Development Application DA 2024-1835

10-12 Clifford Ave and 33-35 Fairlight Street, Fairlight

We, the owners of 2/11 Clifford Ave Fairlight wish to raise our strong objection to this proposed development because it is gross overdevelopment, does not comply with the LEP FSR and height controls of MLEP.

Extract of Council Flood Hazard Map

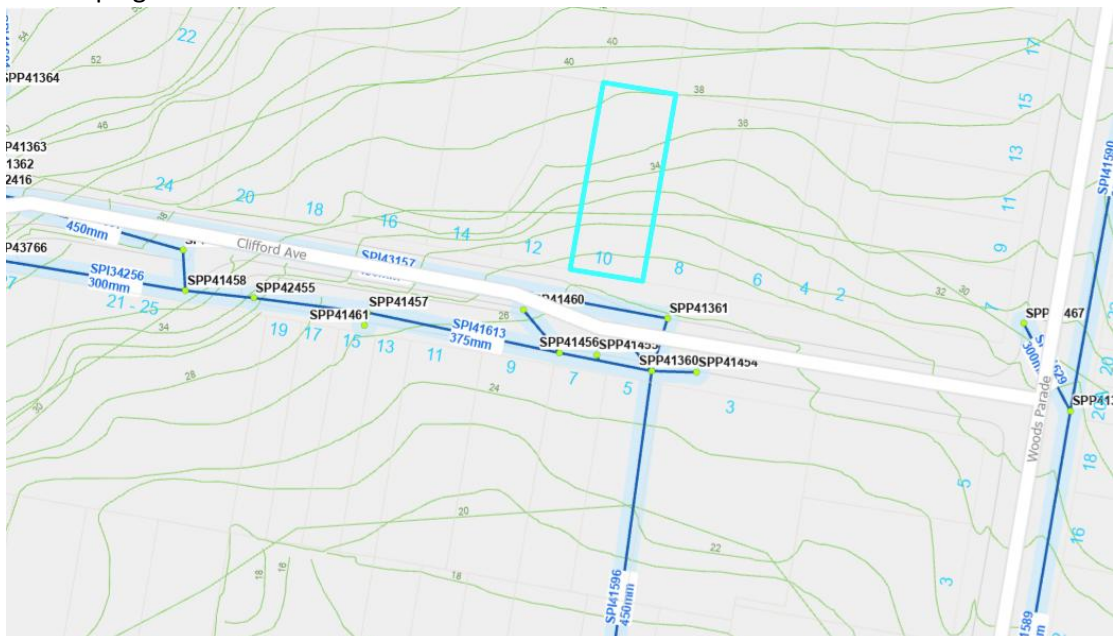
The Council's Stormwater Infrastructure Map depicts that stormwater from Clifford Ave is conveyed downstream via a stormwater pipe that extends beneath No 5 Clifford Ave.

The concentration of all stormwater from the properties on the northern side of Clifford Ave as well as the road drainage results in localised flooding which affects properties on the southern side of Clifford Ave. this flooding is identified on the Council's flood hazard map.

Localised flooding has been witnessed by current Clifford Ave residents with access to some properties restricted due to levels of even moderate rain.

There is concern that the proposed development will further add to the flooding. It has not been demonstrated that the existing drainage infrastructure can support the proposed development and associated runoff.
